ITEM: Miscellaneous Text Changes to Draft Land Development Code

SUMMARY AND ACTION REQUESTED:

The following Staff report is provided in response to discussion at the January 28, 2010, Planning Commission Work Session.

Grid Street Pattern

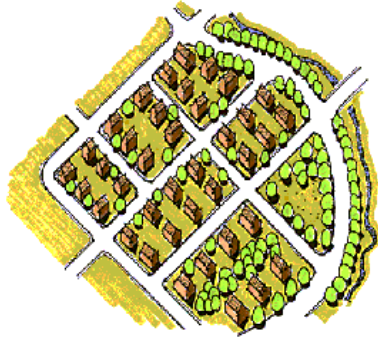
- Figure 3.17 – The Commission felt that this graphic for a multi-family residential development seems to advocate culs-de-sac. Staff has revised the graphic to more clearly show a differentiation between the street that the building fronts and the driveways leading to the rear-loaded garages for the development (Attachment #1).
- Table 3.11-3 clarified – The Commission requested a note to the Table clarifying how it should be read. Staff has revised this Table (Attachment #2).
- Add definition/graphic for “grid street” - The following is a definition and graphic:

A network of parallel and perpendicular streets intersecting at 90-degree angles, forming rectangular blocks of land (see Figure ____).
